Anonymous Referee #2

This work presents an extensive and detailed report of the retrieval algorithm of HCHO for TROPOMI on board of Sentinel-5p. I believe that the manuscript is clearly written and well suits for the AMT so I recommend the publication with a few minor comments for clarification as follows:

Figure 1: Estimated random error on the HCHO SCD, as the limit of the first window is increased. Window A is the large window (328.5-...), window B is the small window (328.5-346.0).

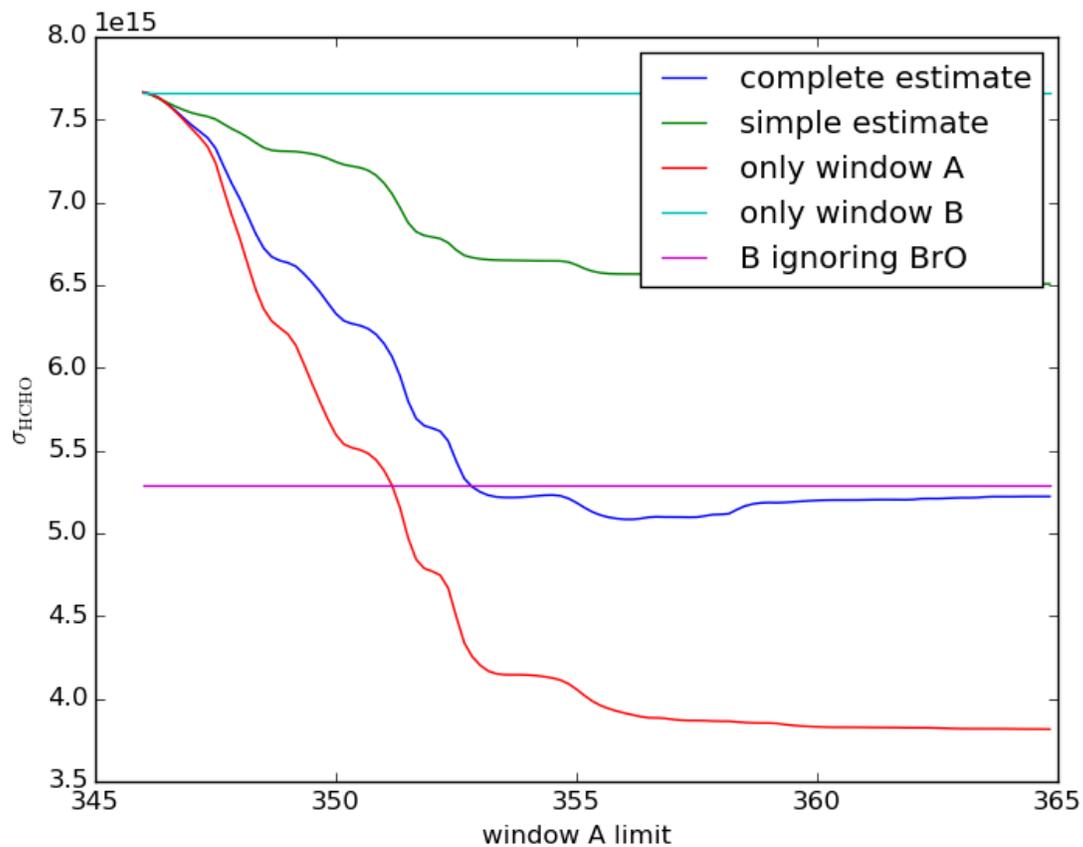
L237-239: The BrO retrieved from the first fitting is used in the second fitting and its error may affect the retrieval of HCHO in the second fitting but the error analysis associated with this was not included in the manuscript.

We made estimates of full random error calculation, when using coupled analysis intervals. The plot below shows the estimated random error on the HCHO SCD from the least squares estimation, as the limit of the first larger window is increased. Window A is the big window (328.5-...), window B is the small one (328.5-346.0).

The red line is the error in the large window (only window A). The light blue is the error when everything is fitted in the small window, without constraints (only window B).

The dark blue is the calculated random error when BrO is constrained in window B using the estimate from window A (complete estimate). The error reaches an optimal value when window A goes up to ~356nm, as done in our algorithm. The green "simple estimate" is the result when ignoring the correlations between the BrO estimate and the results in the small window.

The violet line (B ignoring BrO) is what our actual version of QDOAS provides in the case where 2 coupled fitting intervals are used. This means it just ignores the error from the BrO estimation. So for the settings we currently use, it's quite close to the result from the full calculation.

This theoretical estimate confirms the 50% reduction of the random error in the small interval when pre-fitting BrO in the large interval, as observed with real data (figure 1 of this review).
